Technical Service Bulletin: TSB160020

Released Date: 07-Mar-2016

New Cylinder Head Capscrews and Torque Specification Revision

Figure 4, Capscrew Torque Sequence

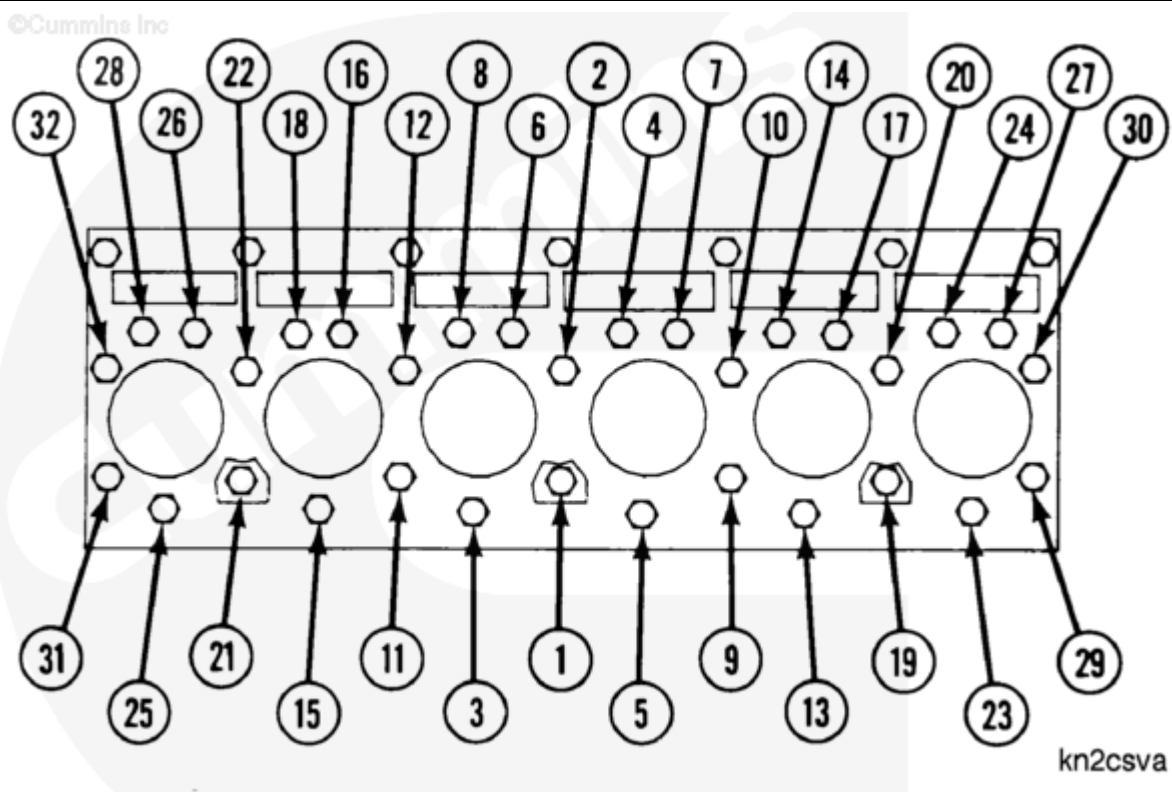
The installation procedure for cylinder head capscrews has also been revised to the torque plus angle method.

All 32 capscrews **must** be rotated 180 degrees after having been torqued to 136 N•m [100 ft-lb]. Make a mark on the cylinder head as a reference. Rotate the capscrew until the mark on the cylinder head is more than two flats but less than three flats.

When using torque plus angle, the tolerance on the 180 degree angle of rotation is between two and three flats. If the capscrew is unintentionally rotated beyond three flats, do **not** loosen the capscrew. The clamp load is still acceptable. However, rotating the capscrew beyond three flats reduces the number of potential reuses.

Tighten the capscrews in the sequence shown in Figure 4 to the specified values:

Torque Value:

1. 68 N•m [50 ft-lb]
2. 136 N•m [100 ft-lb]
3. Rotate 180 Degrees

Note : Rotate at least two flats, but not more than three.

Figure 1, New Flange Head Capscrew.

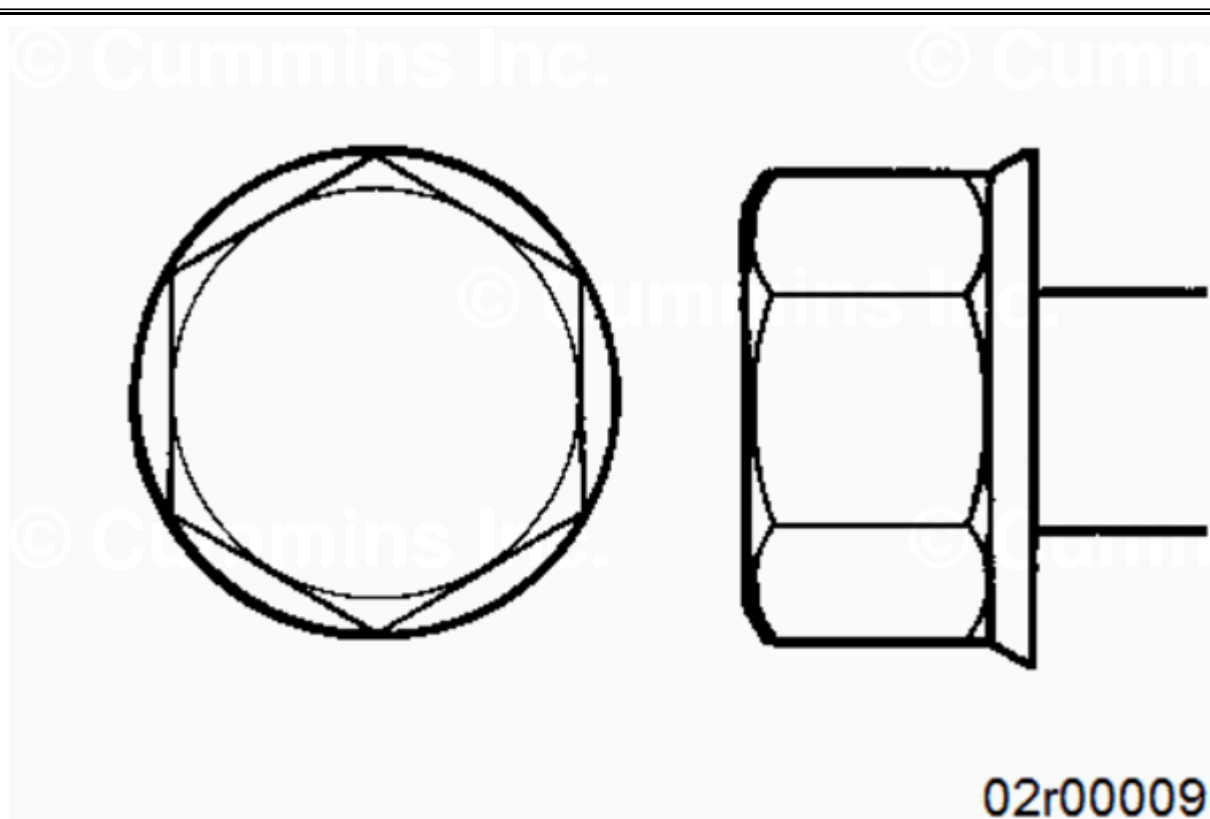
This document introduces new cylinder head capscrews. The new capscrews are a flange head style capscrew and eliminate the need for the hardened washer, Part Number 3019631.

The new capscrews have improved corrosion resistance and the torque plus angle installation procedure produces higher and more consistent clamp load for the cylinder head gasket joint.

- The hardened washer, Part Number 3019631, must **not** be used with the new flange head capscrews, Part Number 4022907 and 4923187.
- New flange head capscrews and capscrews with hardened washers can **not** be intermixed on the same engine.
- If replacement of a capscrew with a hardened washer is required and a like part number is **not** available, all 32 cylinder head capscrews **must** be replaced with the new flange head capscrews.
